Product Change Bulletin

6-21-2011

Magnum

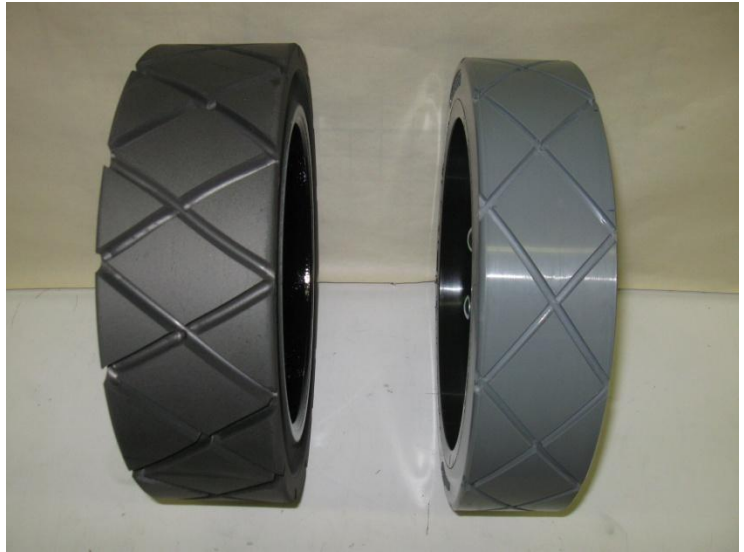
Solid tires have traction loss

We decided to go with a different tread pattern and material to improve traction on various floor types. The improved tread pattern allows more gripping power even on wet floors. Also the grey tire is an aesthetic improvement.

Black or grey metal rim tire

253-6197D – Qty. 2

Prop the machine up on a wooden block or something that can support the weight of the machine on its frame. Remove the nuts holding the tire on, knot out the studs from the transaxle and replace with the longer studs. Make sure the bushings are installed on the wheel opposite the transaxle. Slide wheel onto studs, add the Nylocks and tighten.
